CITY OF ALBANY  
Public Works Department

ADDENDUM NO. 1

ST-18-02,  
SANTA MARIA AVENUE IMPROVEMENTS

Project Number **6289**  
Sheet Number **402**

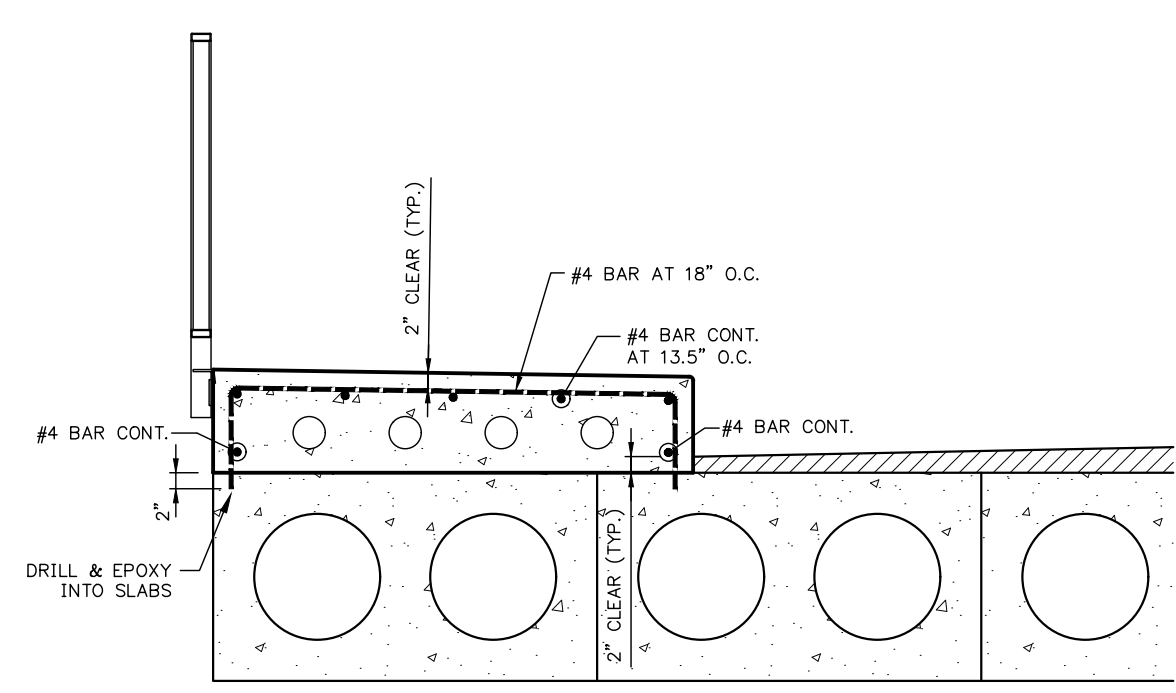
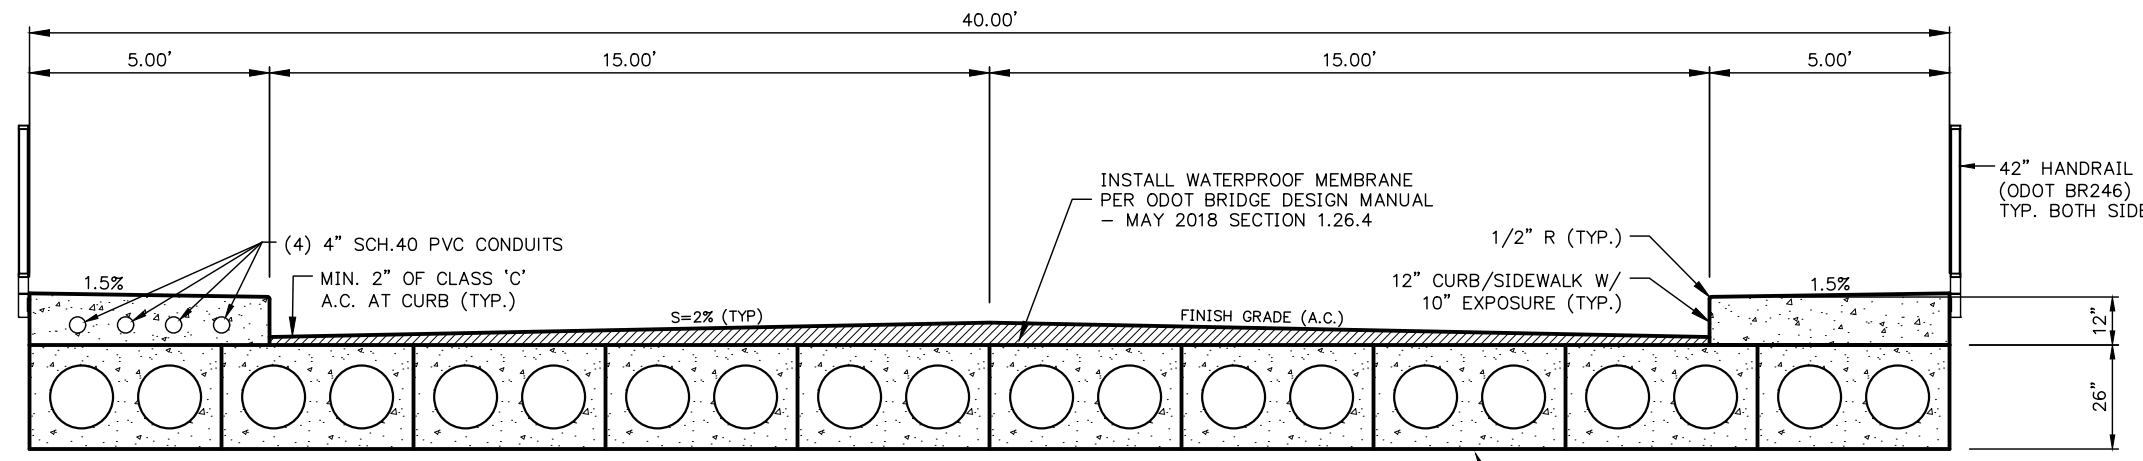
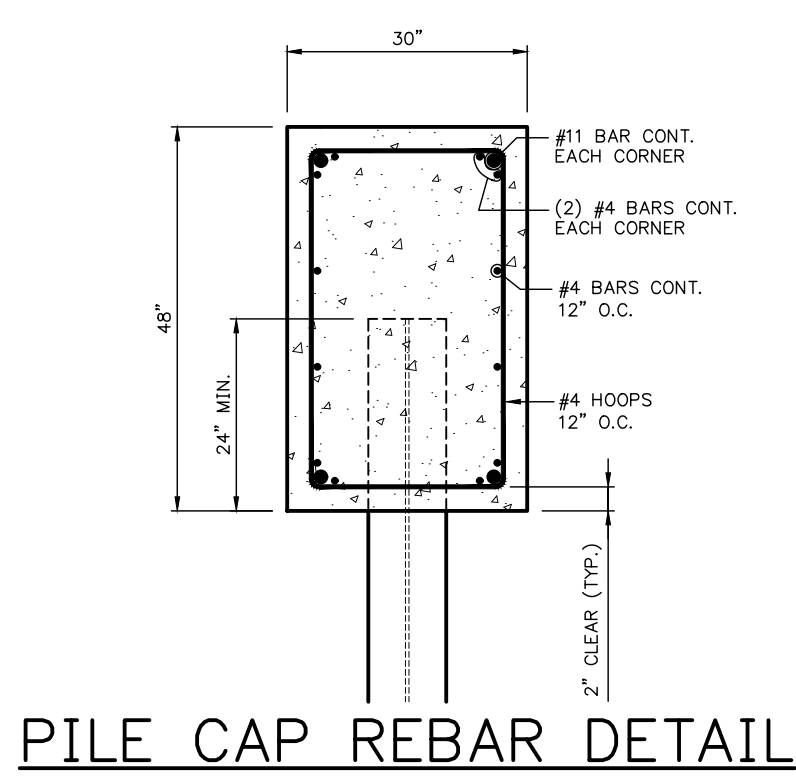
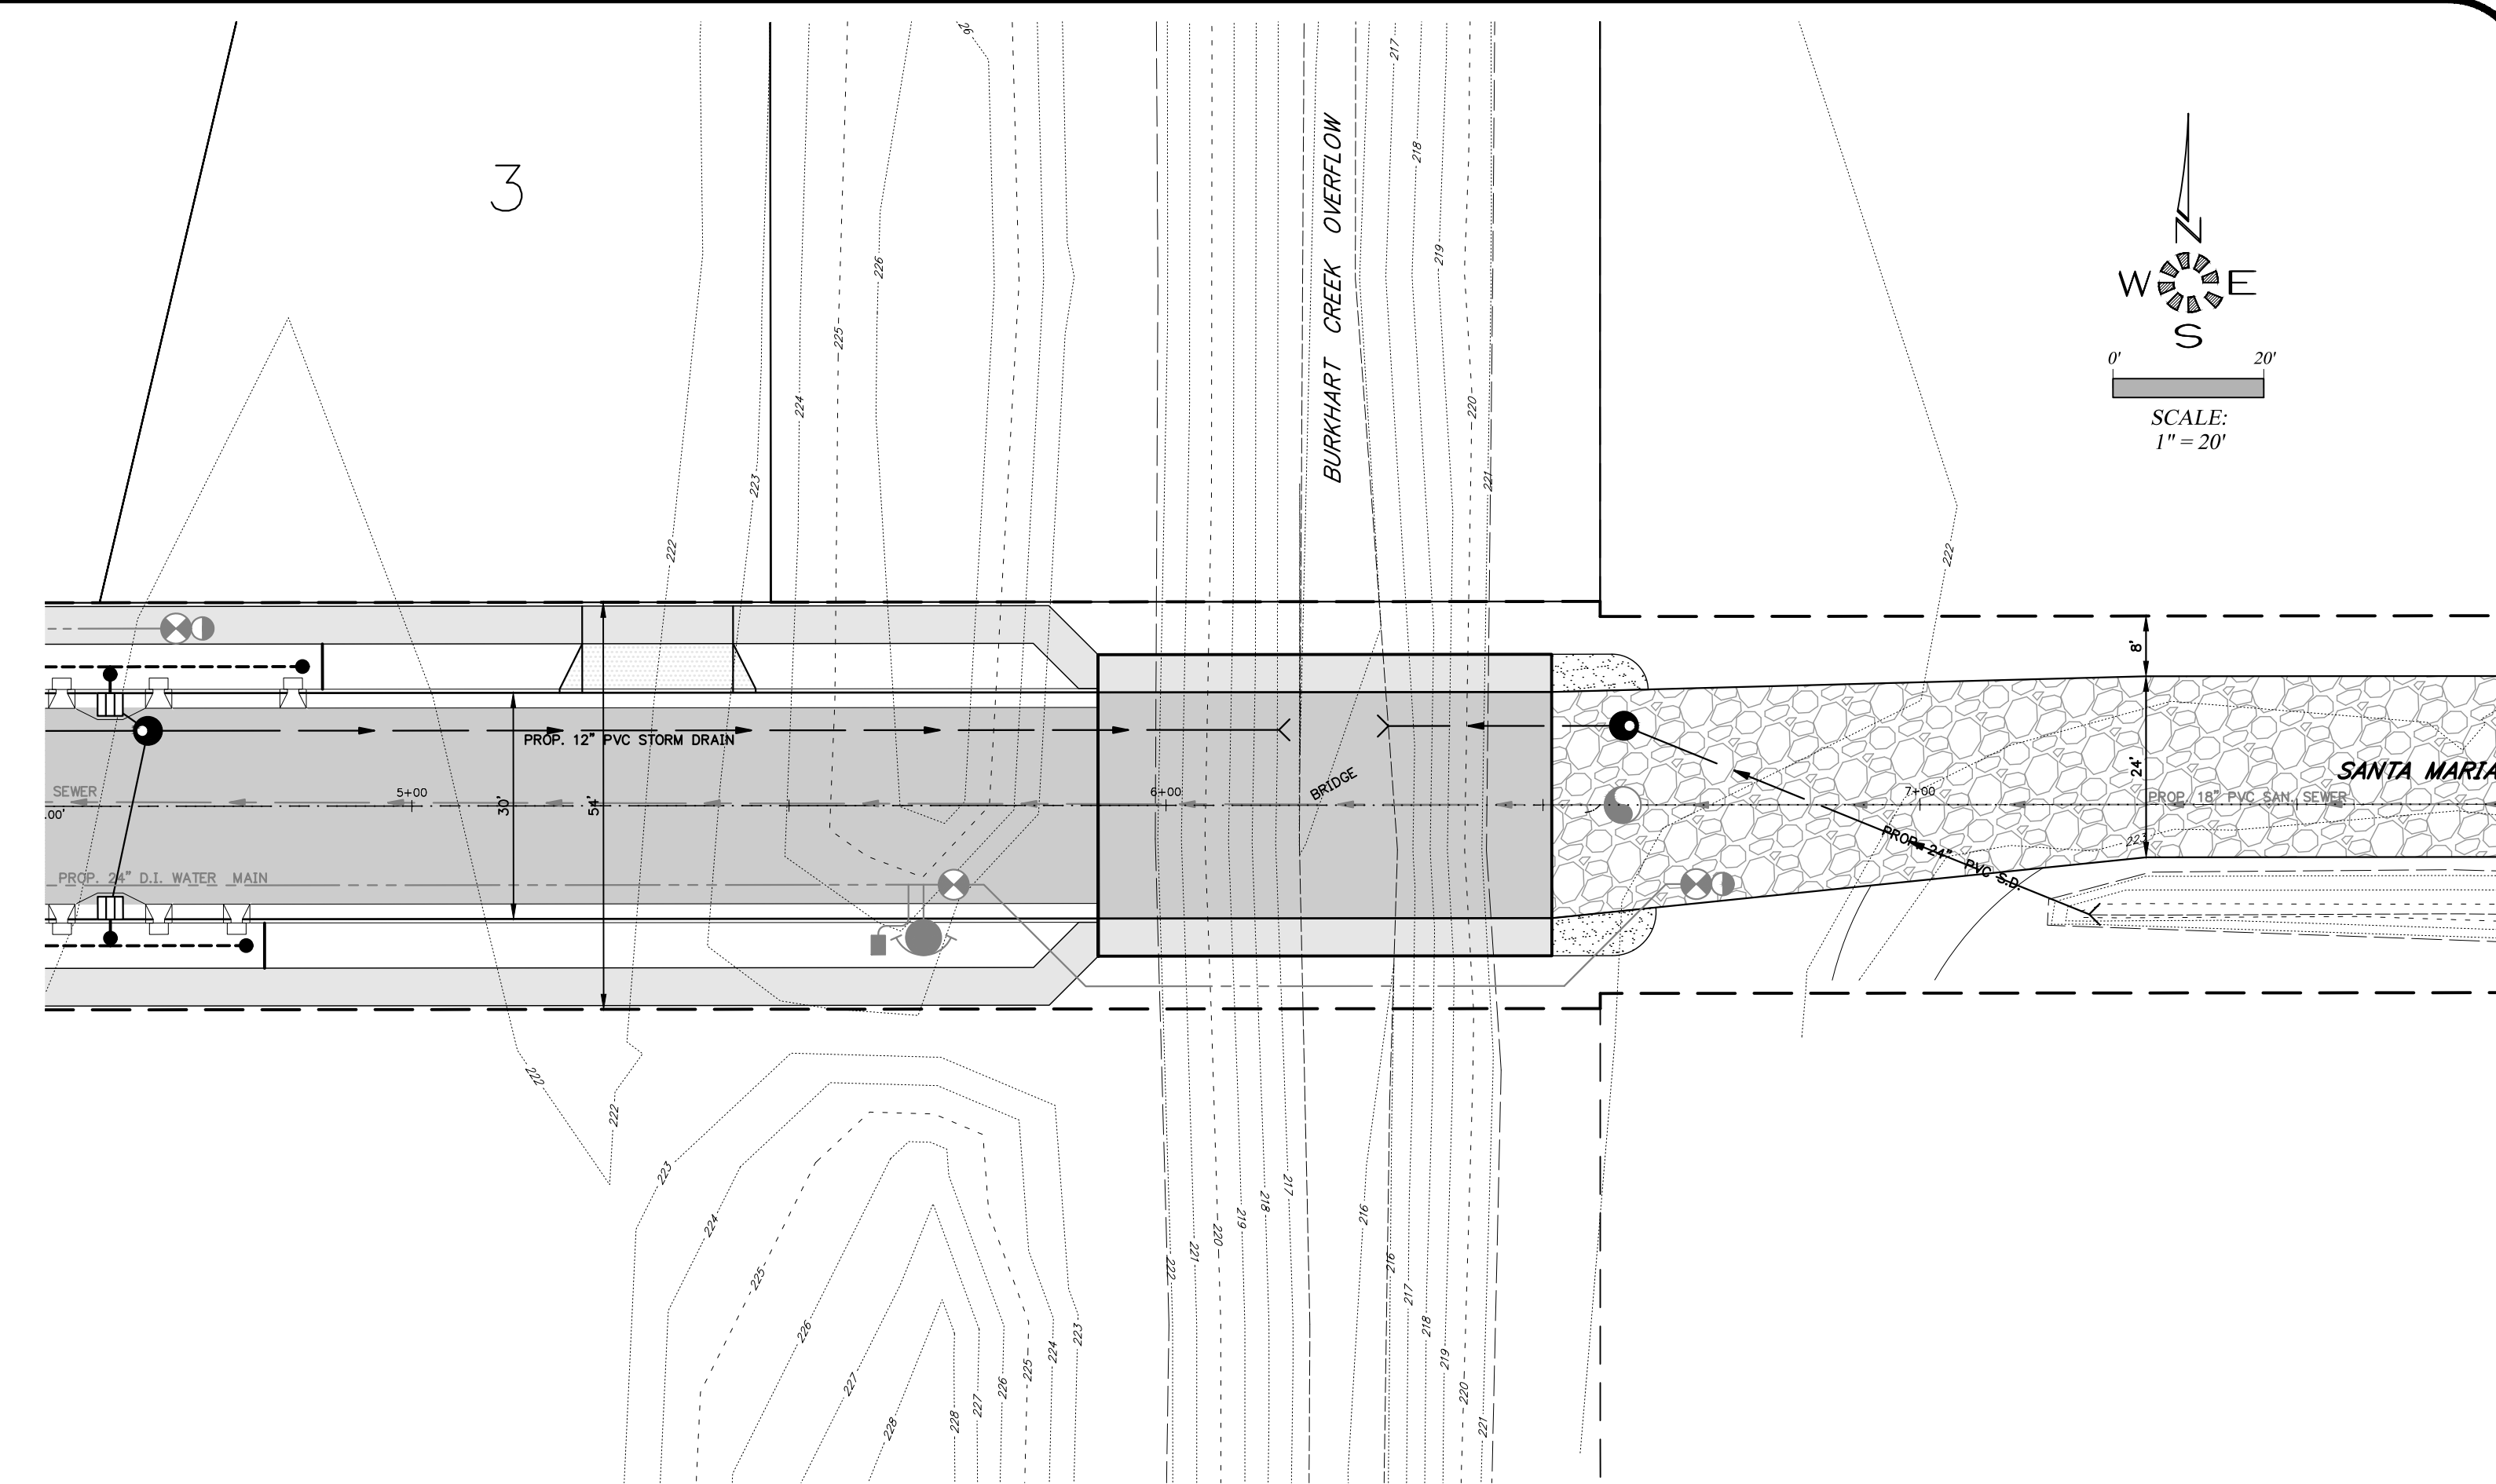
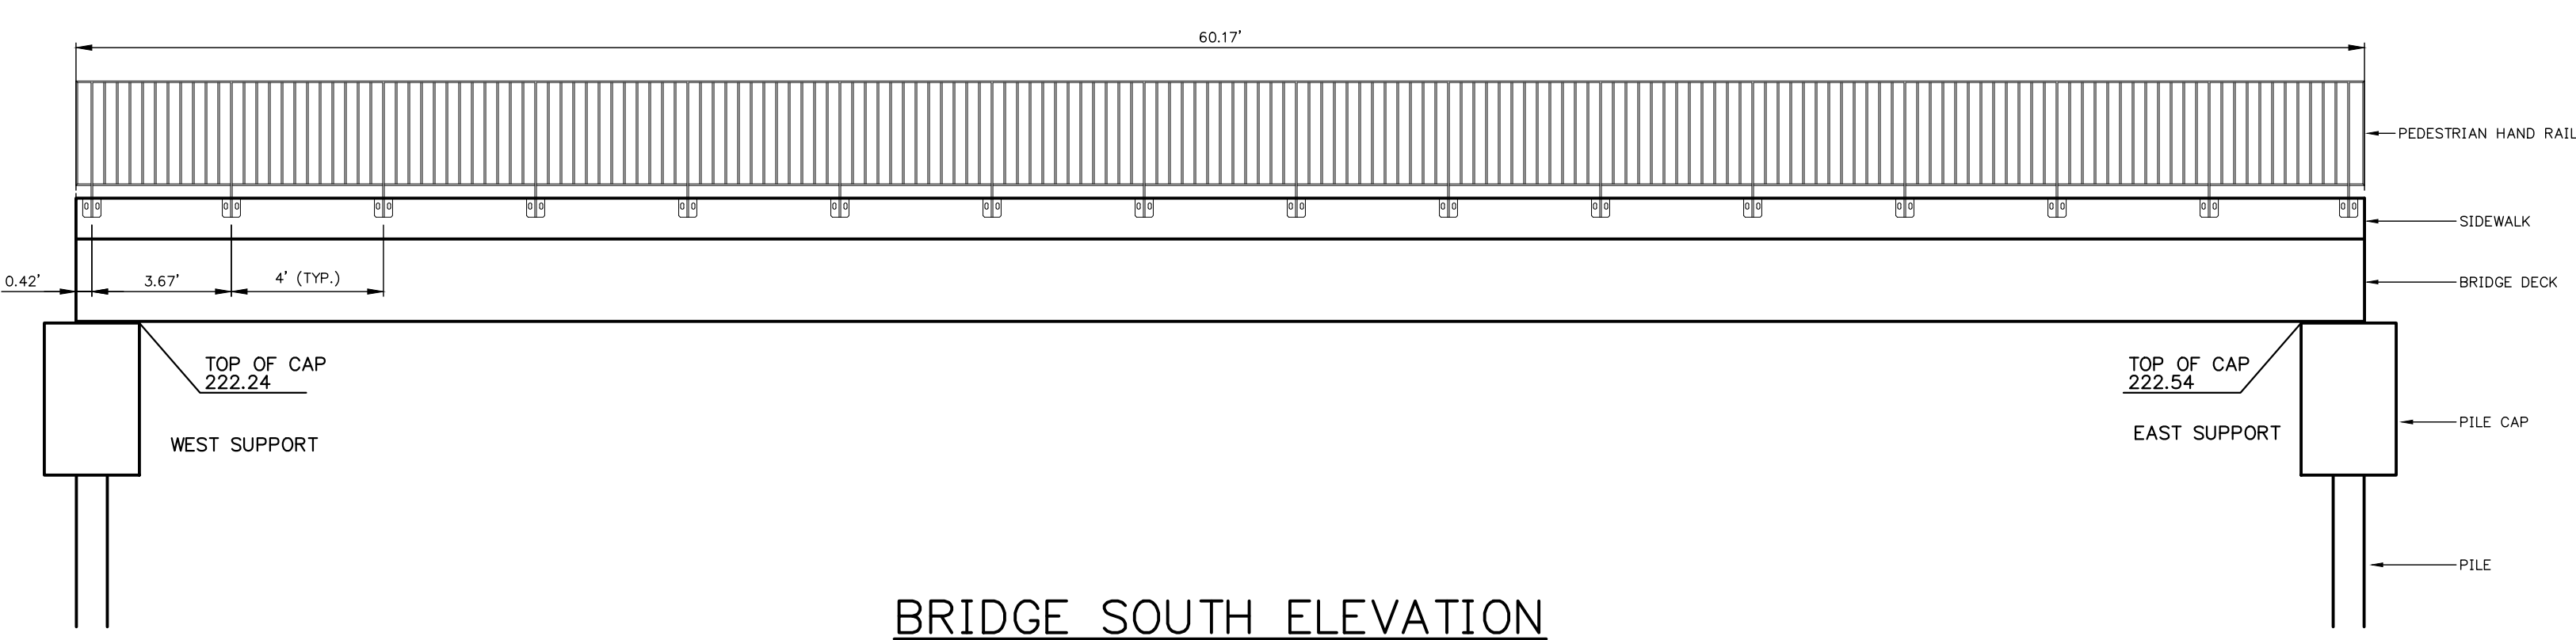
Replace existing Sheet No. 402 with the new updated version of Sheet No. 402. The new drawing updates the note for the pedestrian handrail to include a reference to ODOT Standard Drawing BR246.
